USC Reference: USC131  
Council reference: MCU2026/0003  
SARA reference: 2603-51385 SRA

## **INFORMATION REQUEST RESPONSE 3-9 NORMAN DUNGAVELL DRIVE, QUEENTON**

**RESPONSE TO SARA ADVICE NOTICE – 3-9 NORMAN DUNGAVELL DRIVE,  
CHARTERS TOWERS QUEENSLAND  
SARA Reference: 2603-51385 SRA**

**SITE BASED STORMWATER MANAGEMENT PLAN**

Figure 3.2 - Concept Stormwater Plan (STP)

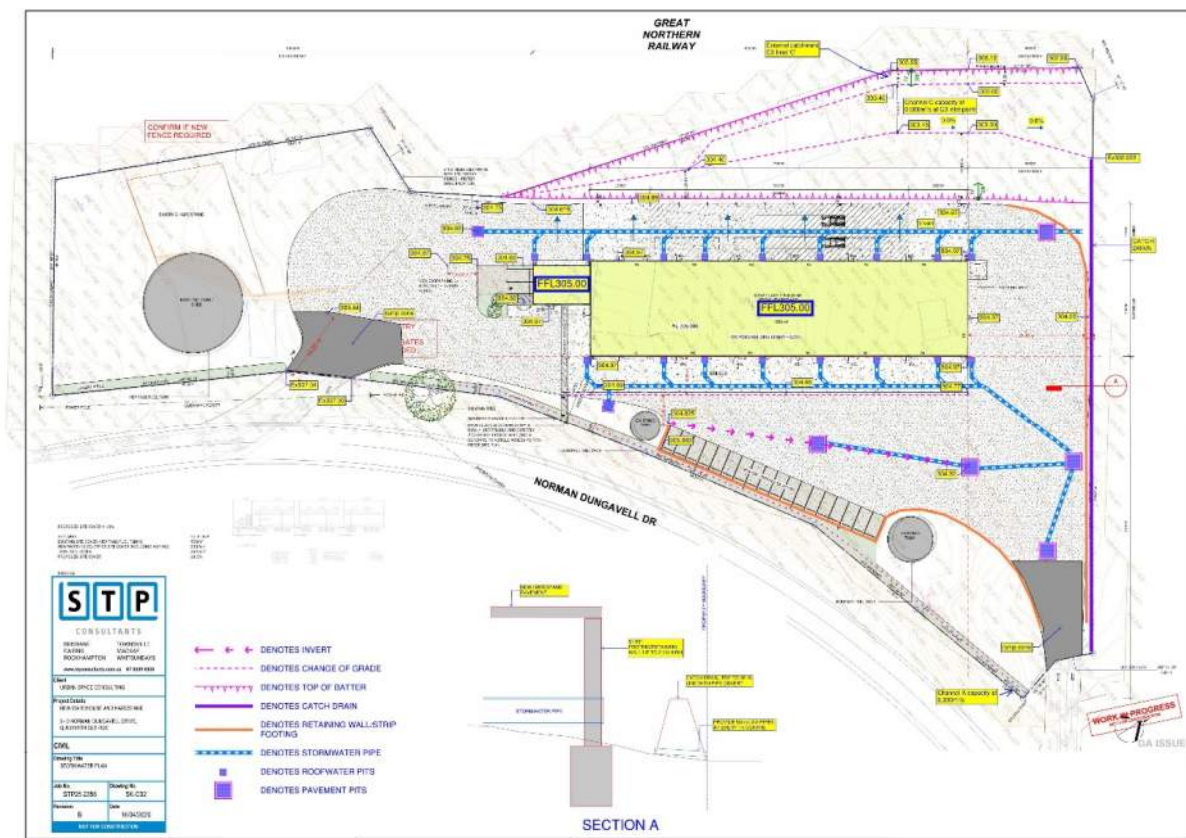
Further detail regarding infrastructure requirements between the site boundary and the road corridor, demonstrating that sufficient frontage width has been allowed to accommodate stormwater drainage infrastructure in addition to other required elements, such as safety barriers and other civil works.

- Details for the swale inside the site are provided in the Site Based Stormwater Management Report. It demonstrates sufficient capacity to accommodate stormwater runoff from the road corridor.

A schematic stormwater drainage plan is illustrated in Figure 3.2. The intent of the plan is to ensure the site catchment is captured through the underground stormwater network and discharged to the adjacent property on lot 46. All roofwater is to be captured by pits and directed to the underground stormwater network. No treatment chamber is required as explained in section 5 – Stormwater Quality.

Figure 4.3 - External Catchments (STP)

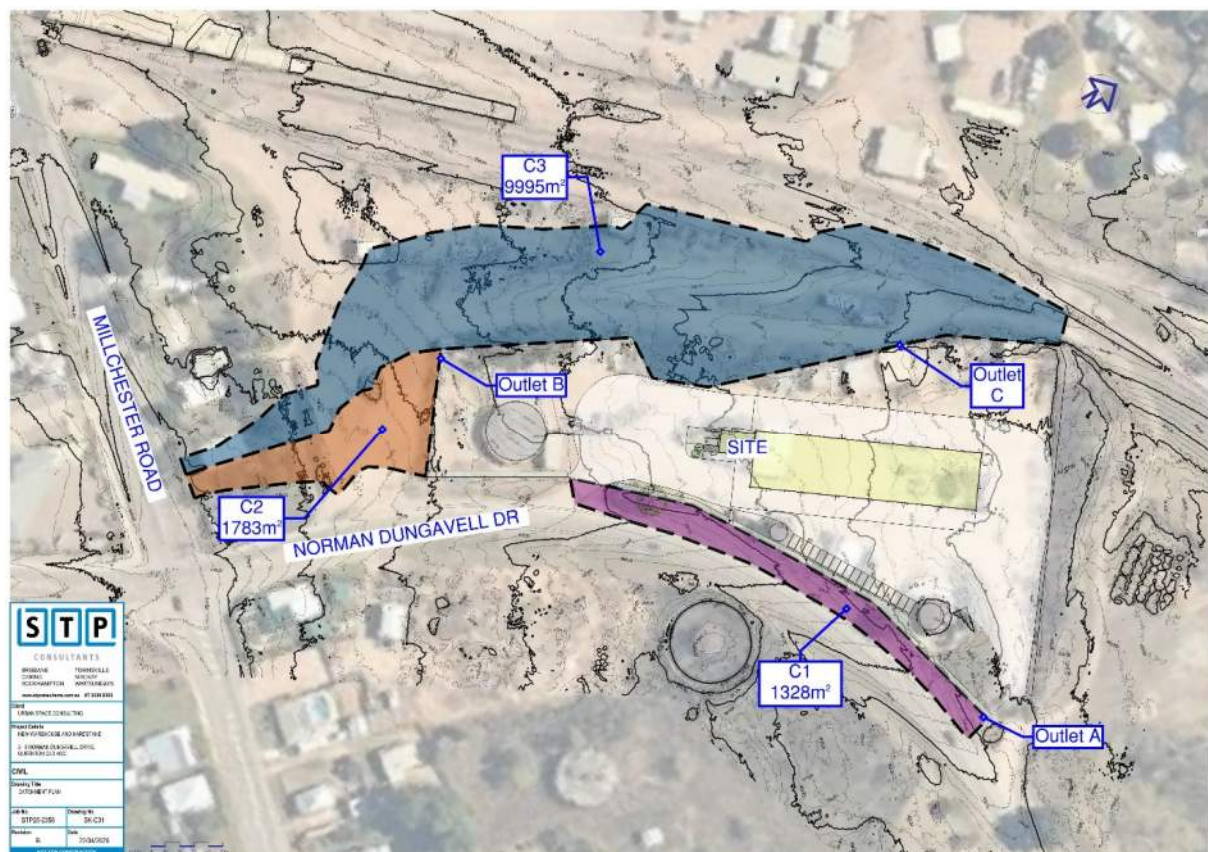
All external catchments traversing or discharging through the site are appropriately managed through adequate stormwater infrastructure provisions. This is to be supported by detailed hydrologic and hydraulic calculations, confirming that the proposed development will not result in adverse downstream impacts to adjoining rail and road corridors.

The site caters for 3 external catchments which are shown in Figure 4.3. These catchment either traverse the whole site or only a portion towards the lower end of the site. The catchments must be accepted, and the stormwater design needs to incorporate the additional runoff.

Catchment C1 will be captured by a swale at the road frontage inside the site. Catchment runoff has been calculated with 80% fraction of impervious and allowed to cater for half the road width. To be conservative, a time of concentration of 10minutes has been adopted. Runoff calculations for all events is illustrated in Table 4.1.

Discharge at Outlet A for 1% AEP event is 0.077m³/s. The swale provides a capacity of 0.090m³/s, which has sufficient capacity to cater for all events including the 1% AEP event.

Catchment C3 contains the largest runoff with a discharge of 0.476m<sup>3</sup>/s during the 1% AEP event. The runoff calculations are illustrated in Table 4.4. To be conservative, a 40% fraction of impervious has been considered into the calculations for any future works or expansions of the rail line. As the catchment largely diverts around the site and only enters at the bottom section of the site, a shallow swale is proposed to be constructed to accept and direct catchment C3 stormwater runoff to the existing point of discharge on the northern boundary. The channel at 'Outlet C' contains a capacity of 0.586m<sup>3</sup>/s which is more than sufficient to cater for all rainfall events of the external catchment.

Figure 4.4 - Proposed impervious Area (STP)

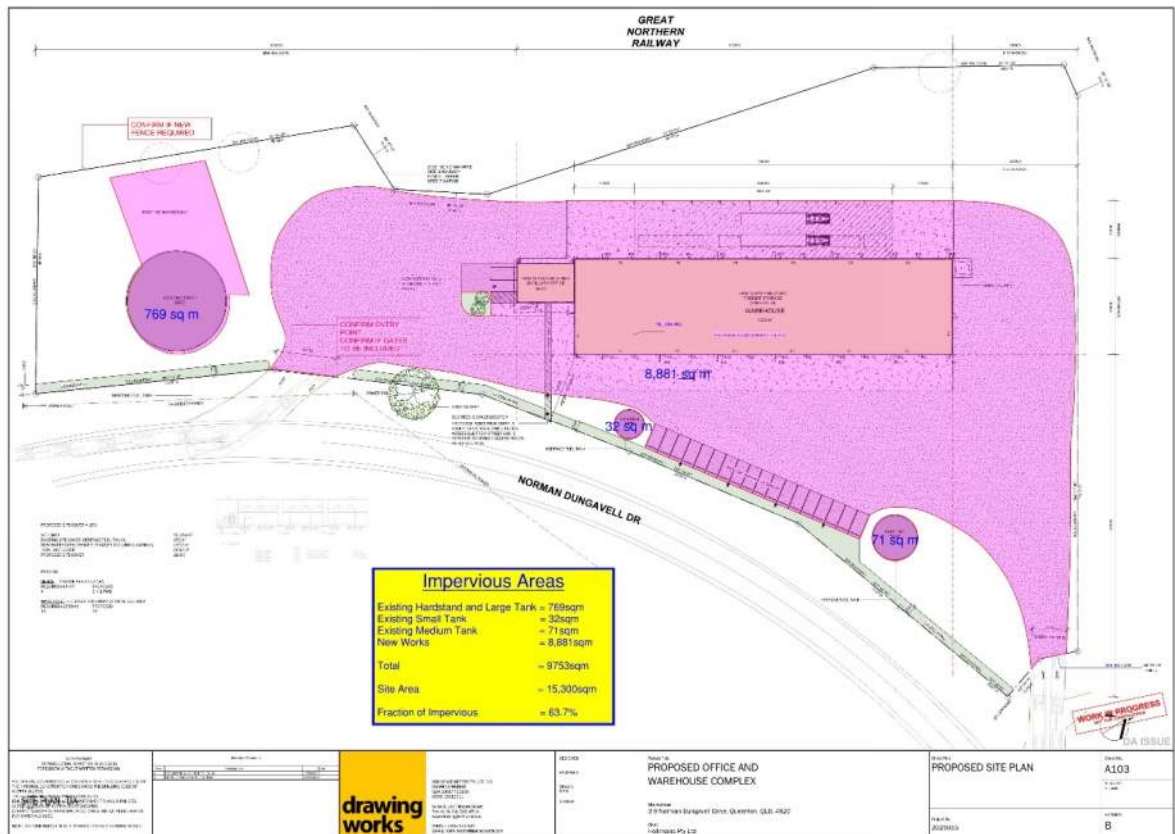
- *The post-development stormwater discharge rates for all storm events up to and including the 1% Annual Exceedance Probability (AEP) event are equal to or less than pre-development discharge rates, in accordance with current requirements.*
- *All external catchments traversing or discharging through the site are appropriately managed through adequate stormwater infrastructure provisions. This is to be supported by detailed hydrologic and hydraulic calculations, confirming that the proposed development will not result in adverse downstream impacts to adjoining rail and road corridors.*
- *Any change to stormwater discharge patterns towards the road corridor and rail corridor must be appropriately mitigated to ensure a no-worsening outcome is achieved, including consideration of flow rates, velocities, and discharge locations.*

The site is currently zoned as Industrial under the CTCR Planning Scheme with a permissible fraction of impervious of 0.9 in accordance with QUDM 4.5. The proposed works contains a fraction of impervious of 0.64%, as shown in Figure 4.2, which is under the allowable limit for the zone and therefore no on-site detention is required.

**DRAWING NUMBER**  
**MOD25169QLD - SK01**

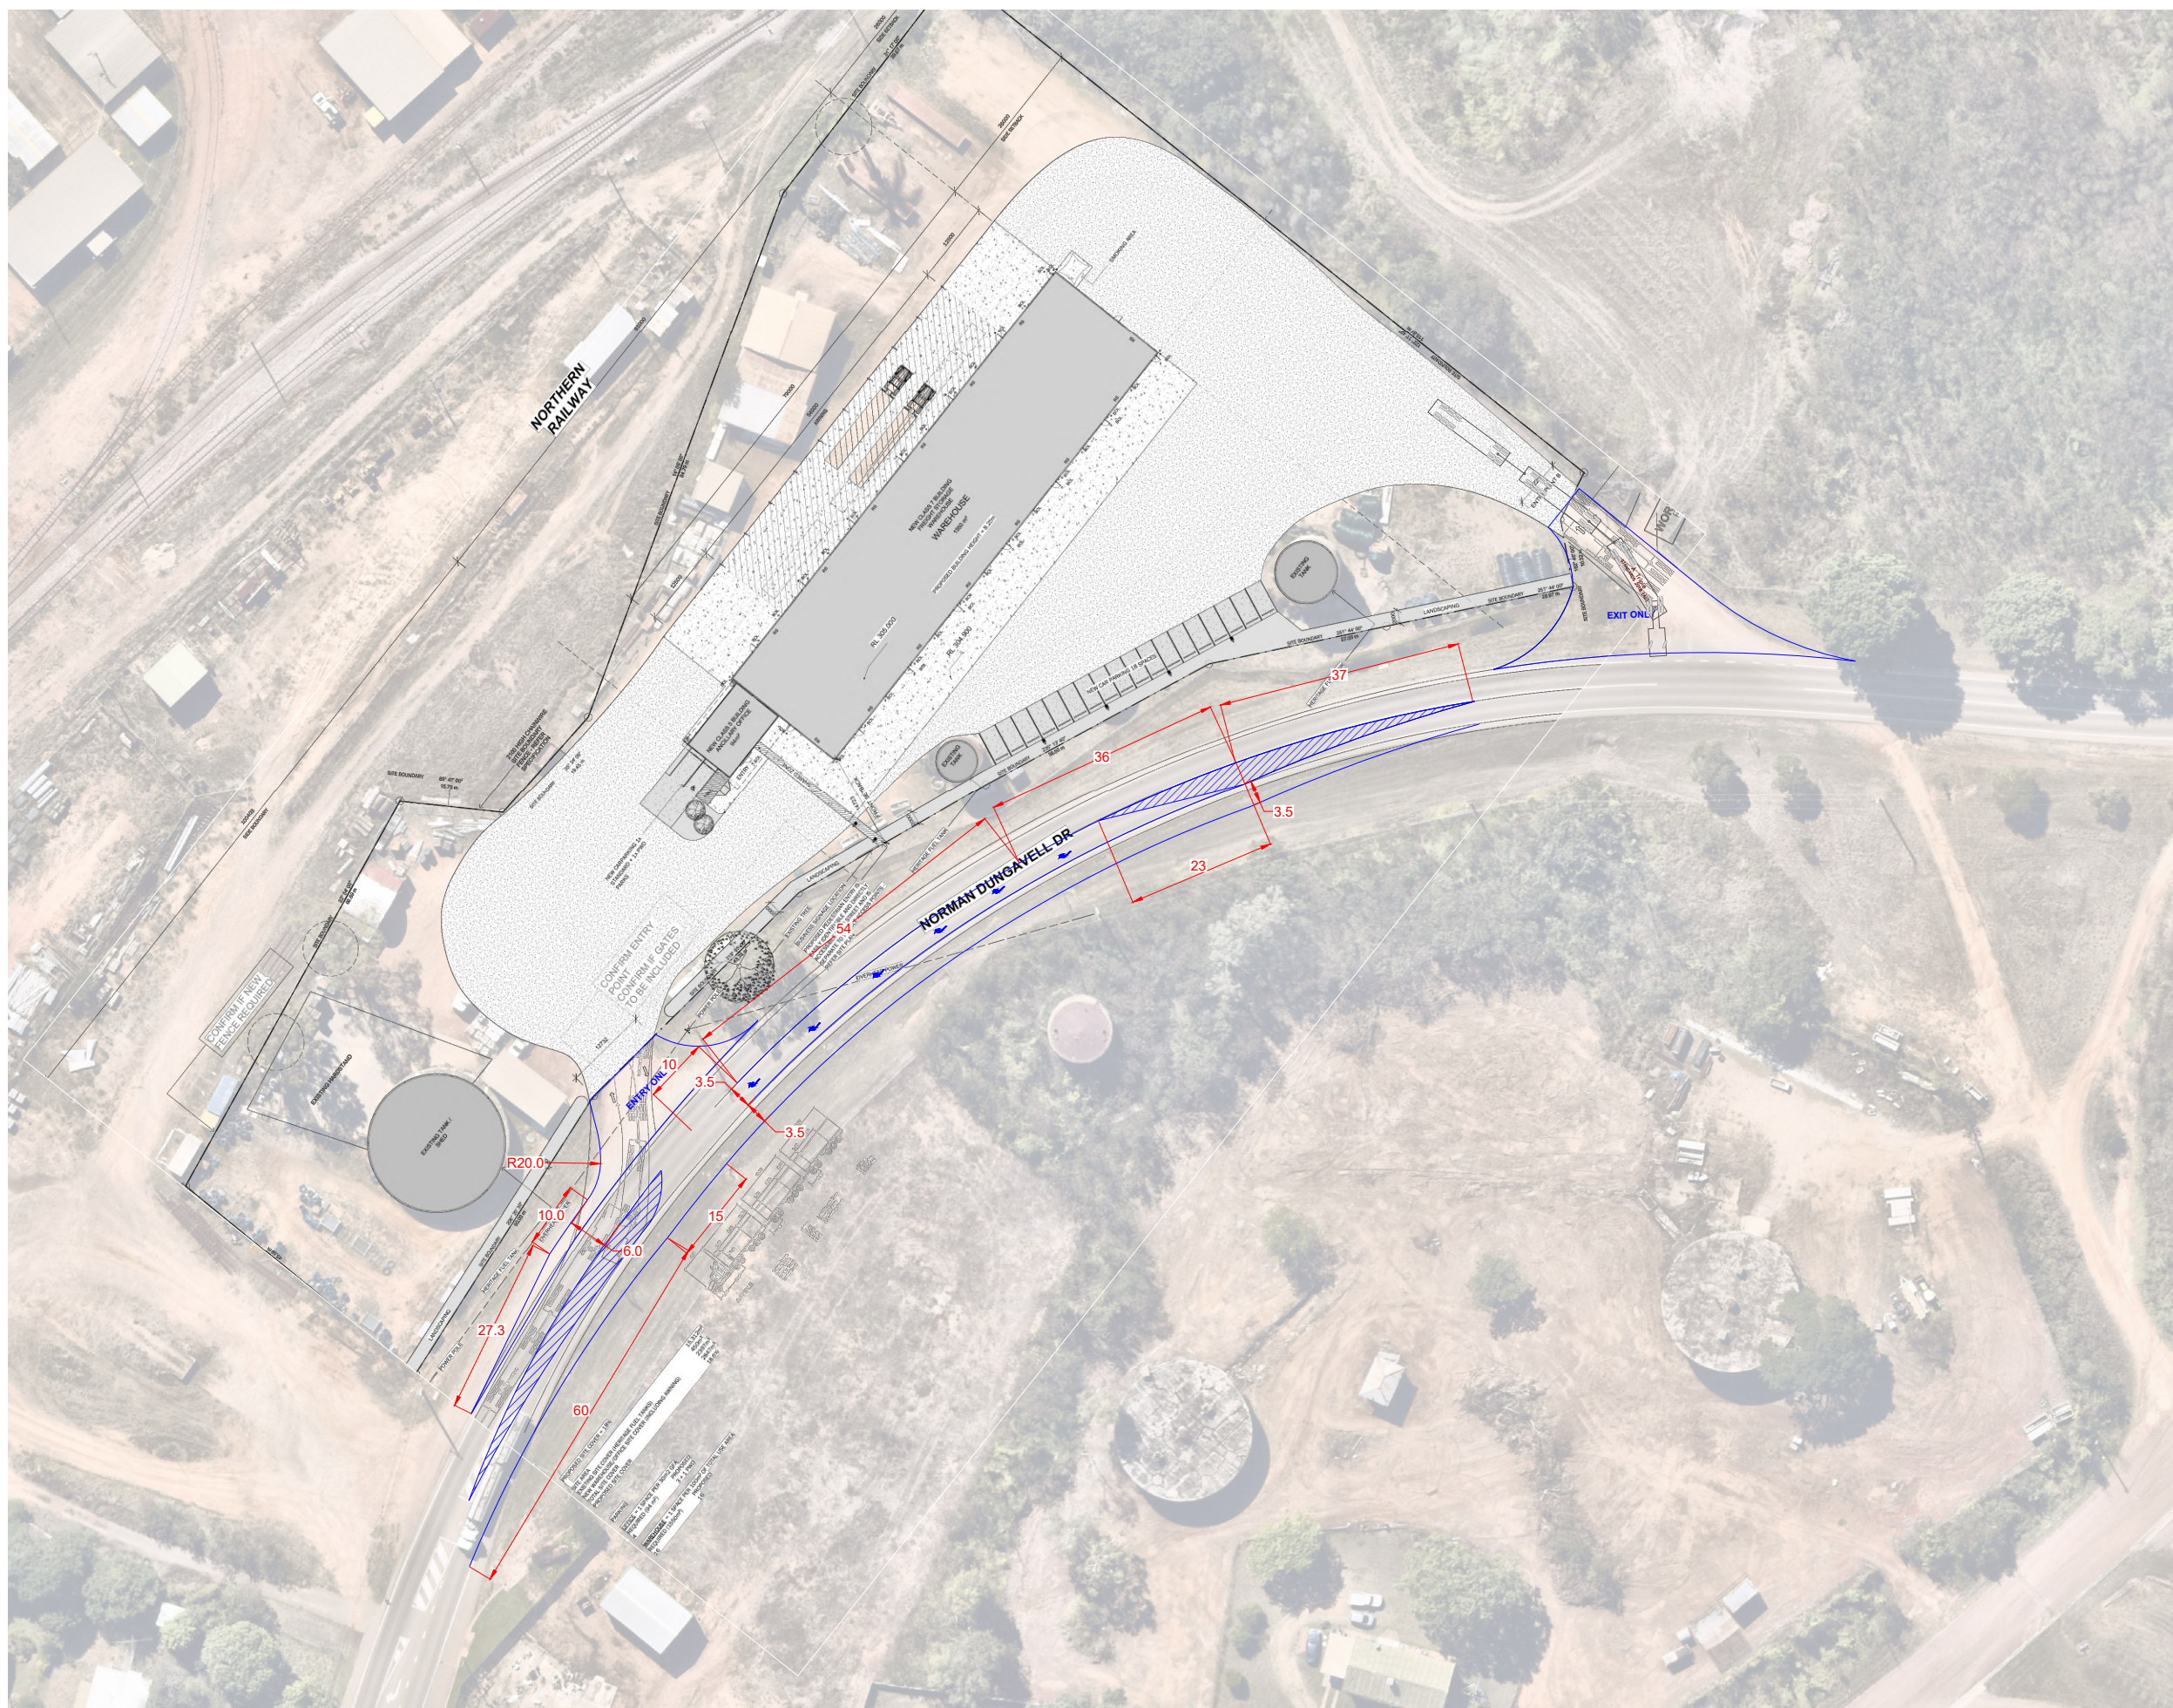
- Confirm that SISD (for trucks) can be provided to the rear of a propped vehicle (car) using the proposed Basic Right (BAR) turning treatment as required by Section 3.2.2 and Figure 3.3 of AGRD4A. If SISD cannot be provided, a Channelised Right (short) (CHRS)) treatment should be provided.

- A plan showing the recommended (Basic Left (BAL)) turning treatment at the proposed entry driveway and details of the proposed signage and linemarking required to restrict entry or exit movements at each driveway crossover.

On this basis, it is recommended that a CHR(s) turn treatment is implemented as demonstrated on the Traffic Plans provided at **Appendix B**.

Furthermore, the Traffic Plans provided at **Appendix B** demonstrate the provision of a BAL turn treatment.
